City of Dublin Planning and Zoning Commission

# Planning Report

## BSC Sawmill Center Neighborhood District – Dublin Village Center Rights-of-Way Plat

Agenda Item	1
Case Number	13-052PP
Site Location	West of Sawmill Road, south of Tuller Road, and east of Village Parkway.
Proposal	A preliminary plat of approximately 7 acres of rights-of-way for new public streets and associated infrastructure in the BSC Sawmill Center Neighborhood District.
Applicant	Steve Simonetti, Edwards Communities Development Co.; represented by Robert Ferguson, EMH&T.
Planning Contact:	Claudia D. Husak, AICP, Planner II   (614) 410-4675, <a href="mailto:chusak@dublin.oh.us">chusak@dublin.oh.us</a>
Requests	Review and approval of preliminary plat application under the provisions of the Subdivision Regulations Section 152.020.
Planning Recommendation	<b><i>Approval of the preliminary plat with 4 conditions.</i></b> Based on Planning's analysis, the proposal meets the requirements of the Subdivision Regulations.

13-052PP  
Preliminary Plat  
Dublin Village Center  
Tuller Road & Village Parkway

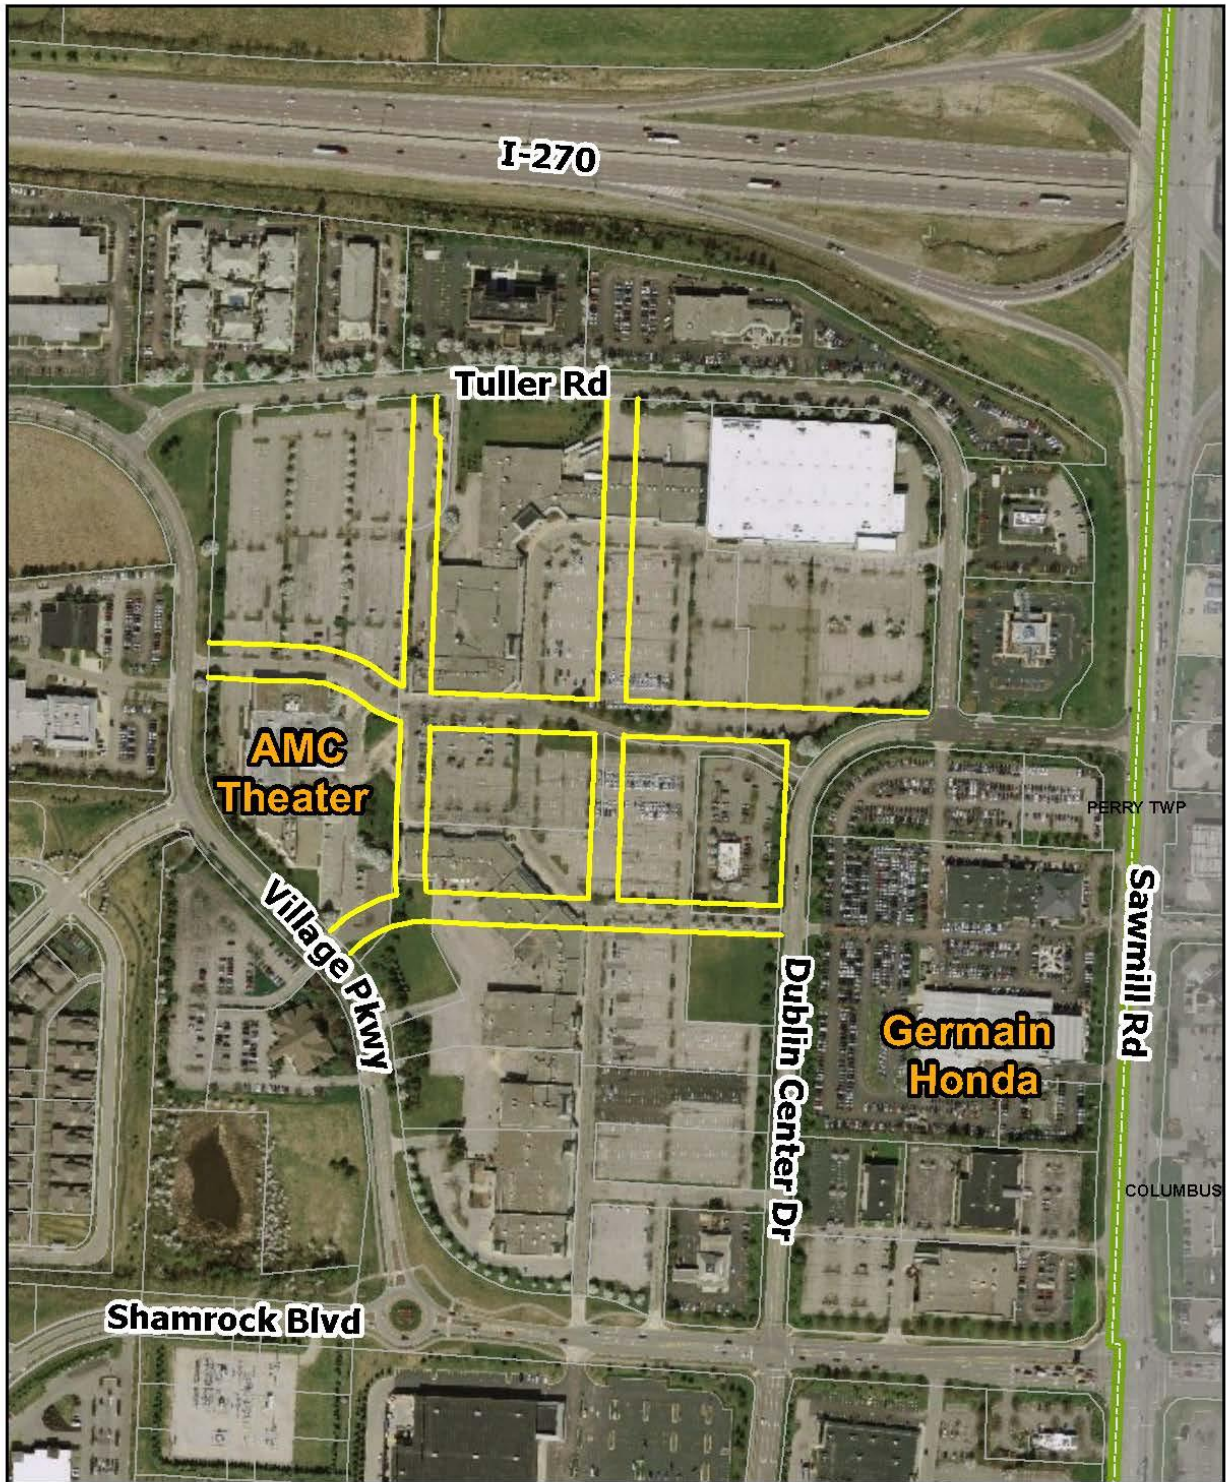
- 1) That the applicant ensure that any minor technical adjustments to the plat are made prior to City Council submittal, including noting the open space ownership and maintenance responsibilities, and setback information;
- 2) That the applicant provide street names for proposed Streets A, B and C prior to submitting the preliminary plat for City Council review;
- 3) That the applicant revise the proposed street section for John Shields Parkway to include a 5-foot tree lawn and a 3-foot sidewalk easement for a 6-foot sidewalk prior to submitting the preliminary plat for City Council review; and
- 4) That the subdivision requirement stating rights-of-way lines at street intersection must be connected with a straight line tangent be waived with this proposal.

further improvements are necessary for the apartment complex. There is a label on page 4 of the preliminary plat that indicates a possible future sanitary sewer extension to this existing line (no linework is shown). Further review of the downstream capacity will be required if this extension happens and if the uses change from the densities shown in the calculations we recently received.

The sanitary sewer service to the southern portion of the project is not shown. A private 8-inch sewer is shown that most likely services the existing shopping center buildings. New public sanitary sewers may be needed to serve future development along Street C.

The plans show the reuse of portions of the existing on-site storm sewer system to provide the necessary drainage for the project. These storm sewers were installed as part of the construction of the shopping center – more than 20 years ago. Engineering is concerned about accepting the existing pipes for public infrastructure due to many factors: age, condition, unknown bedding and backfill of the pipes. The applicant has provided closed-caption televised video of the pipe they wish to reuse. A separate consultant for Engineering will review the conditions of these pipes to provide a recommendation if they are acceptable as public infrastructure. If it is determined that the existing pipes are unacceptable, additional storm sewer will have to be installed to provide the appropriate drainage for the public street.
